Special Board of Education Meeting Regarding the Condition at Lum Elementary School

RE: Donald Lum Elementary School Liquefaction Settlement

Figure 1 - Existing Footing

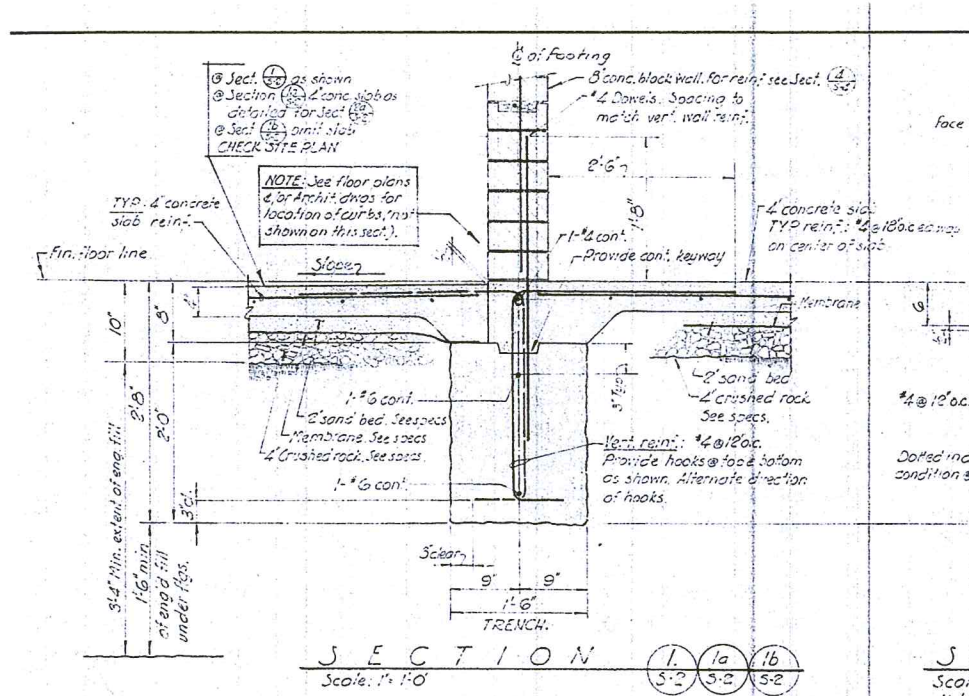
The foundations for the earliest buildings, built in 1959-1964, are shallow, relatively narrow footings with a relatively small amount of steel reinforcing. A typical footing section can be seen in Figure 1. In this example, the footing is 24 inches deep and 18 inches wide with one reinforcing bar in the top and another in the bottom of the footing. The later building, built in 1974, is slightly more robust with more footing reinforcement. These footings were designed to support the building weight directly on the soil below. They are not designed for, or adequate to transfer building weight over significant distances to bridge across soil that has lost its strength due to liquefaction. This was, and is, standard practice for building sites with good or average soil conditions. Even modern well designed buildings generally do not have adequate

foundations to withstand the 7" of expected differential settlement expected at Donald Lum Elementary School unless they were specifically designed for it.

We evaluated the existing footings in a couple of typical locations, using ASCE 41-13 Seismic Evaluation and Retrofit of Existing Structures, to span over a length of 25 feet which is similar to other designs of new buildings on liquefiable soil and in conjunction with the Geotechnical Engineer. Based on our analysis, the footings do not have the strength to span this distance and will likely experience displacement matching the liquefaction settlement of the soil below, leading to partial or global collapse of the structure above.

Figure 2 - Typical New Footing

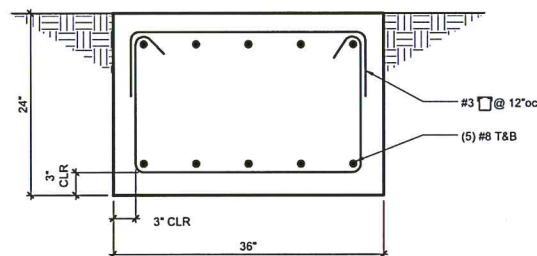
While we believe a stiffened grid foundation to resist the large settlements expected at Donald Lum Elementary School is not the appropriate system for this site, we did calculate what a potential required size might be. Figure 2 indicates a preliminary foundation size for a portion of the building based on a 25-foot unsupported footing length. While this solution is feasible from a structural perspective, it would be difficult or impossible to construct under an existing structure. If pursued, this foundation system would be required to be installed under all bearing walls and in a regularly spaced grid across the building.
